Youth Music Project

An Application For: Conditional Use Permit Class II Design Review

Supplemental Information

In response to November 26 Letter: City of West Linn List of Incomplete Items Submitted December 23, 2013

Sheet Name EROSION CONTROL PLAN

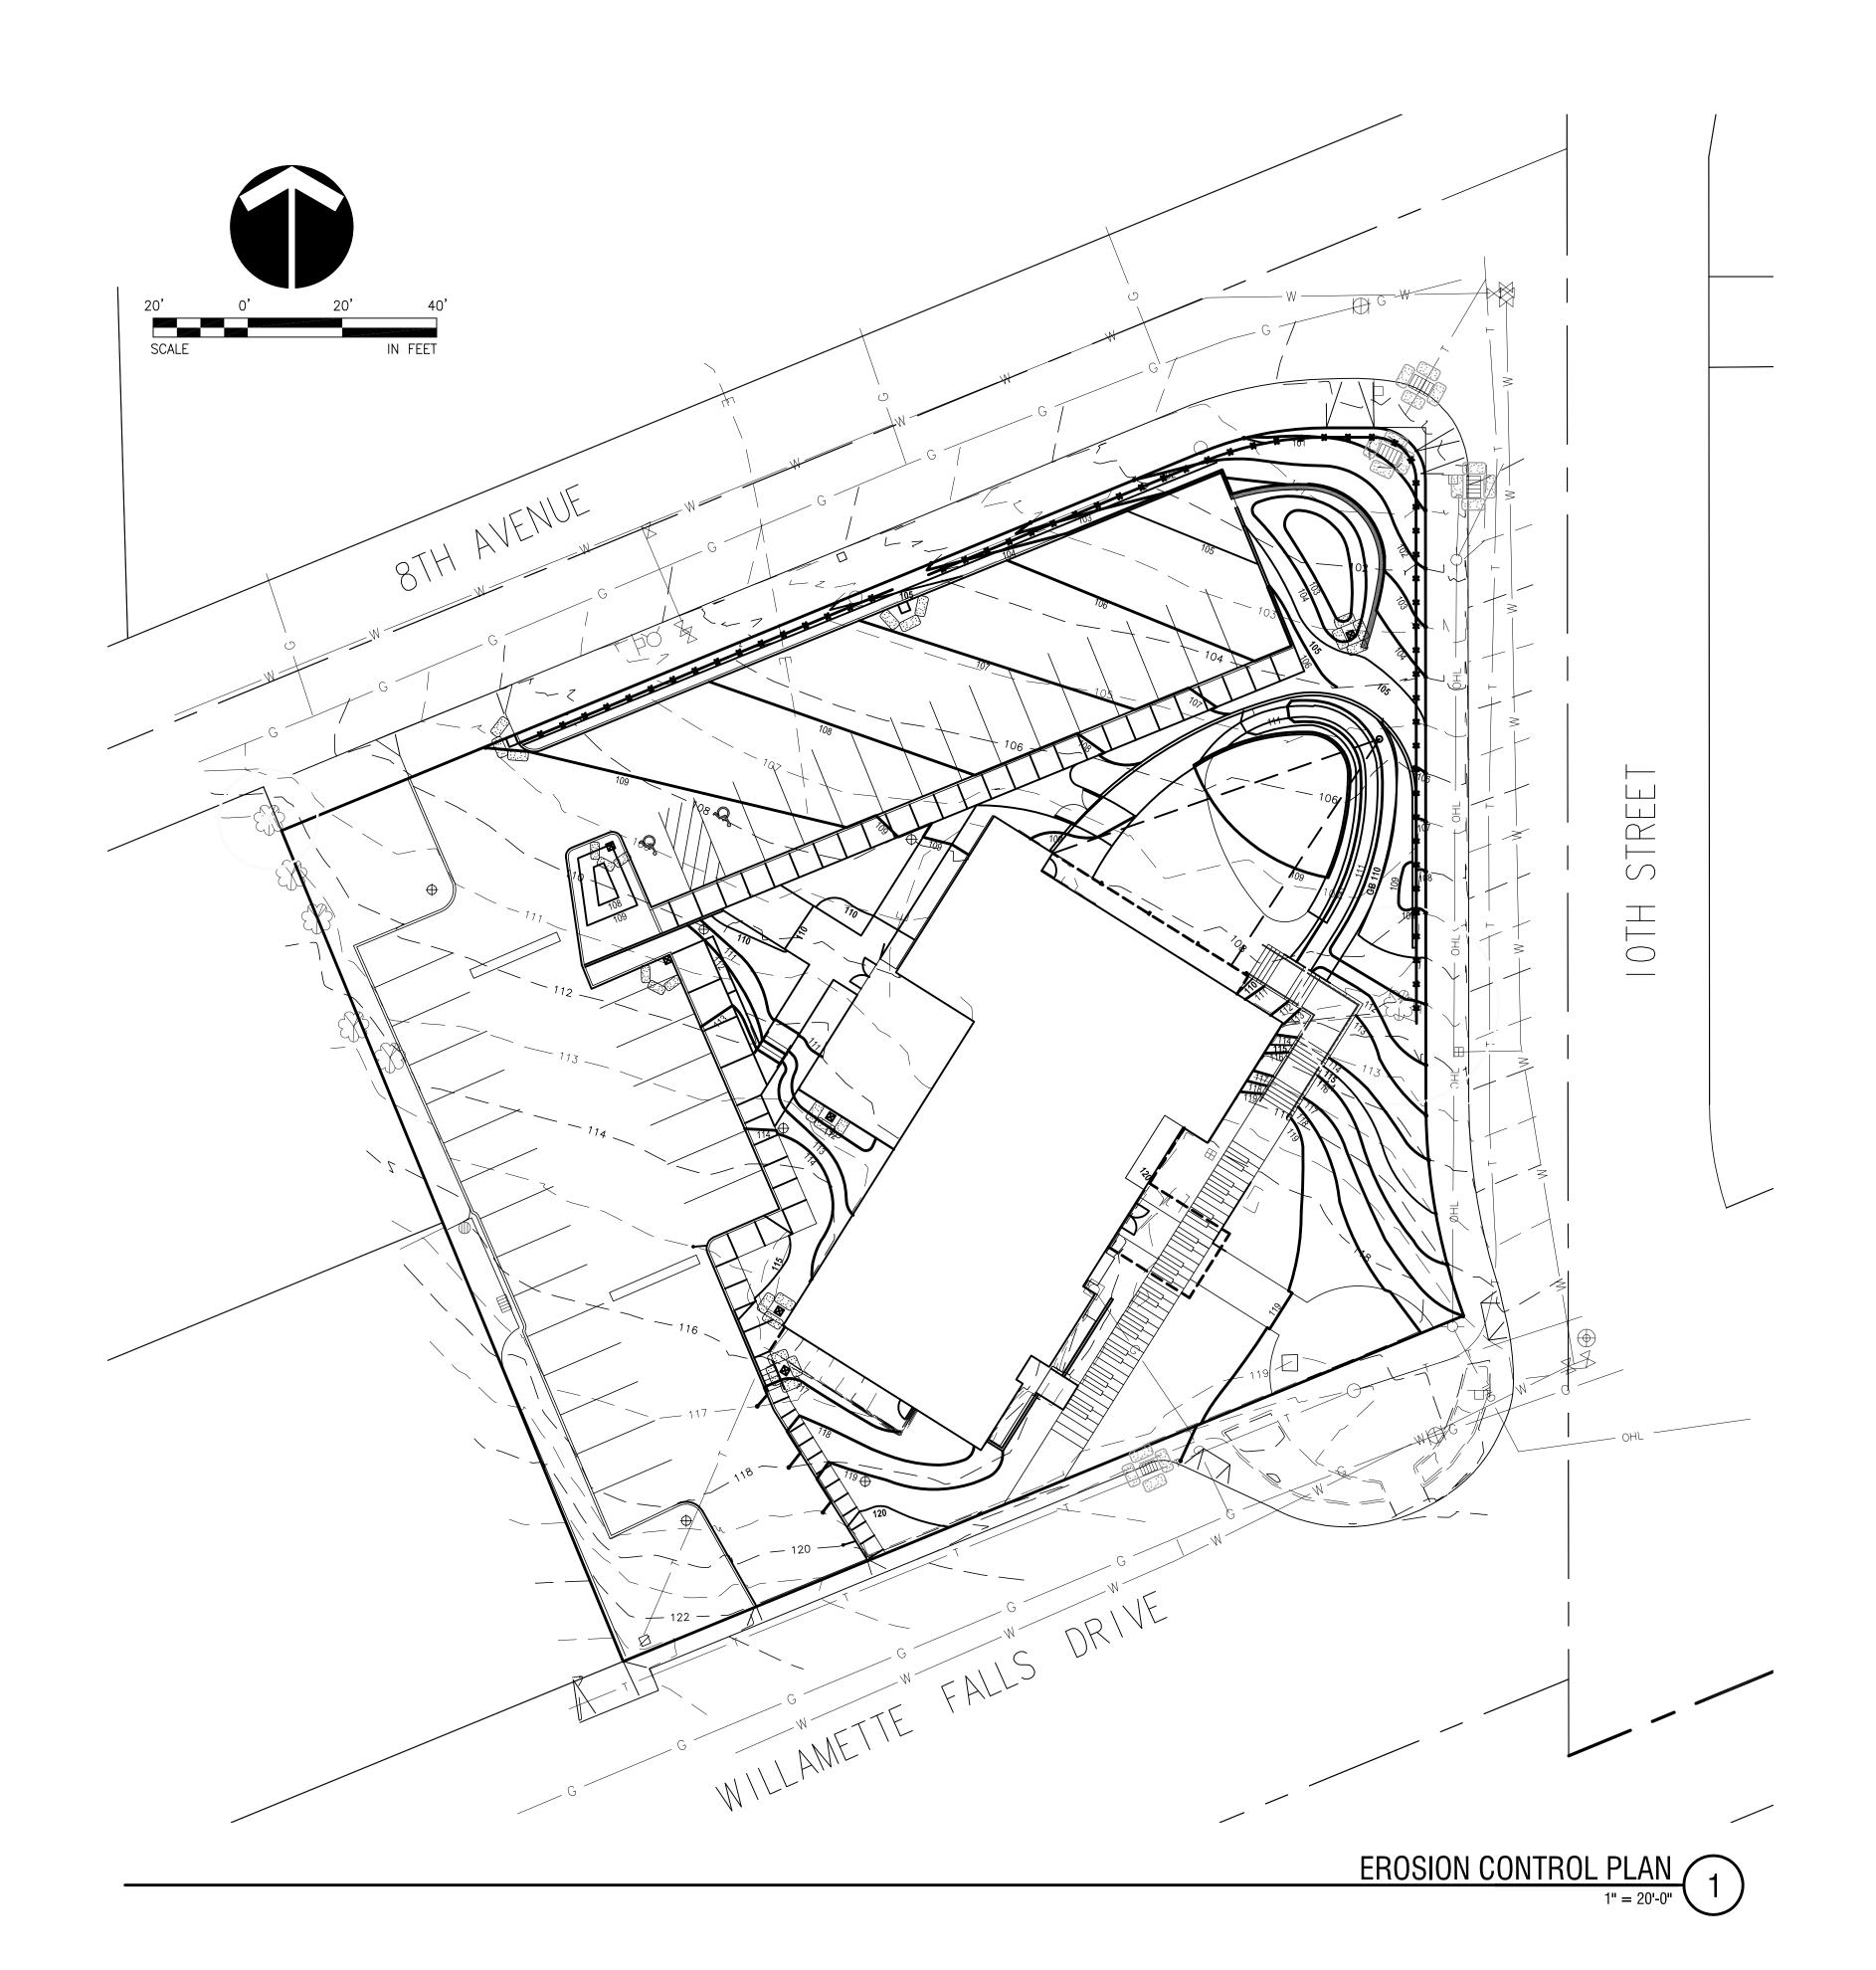
Put engineering stamp on grading plan to show that it is prepared by registered civil engineer. Have engineer provide data statement as described in this section.

- P4.0 Stamped Erosion Control Plan
- P4.1 Erosion Control Notes and Details
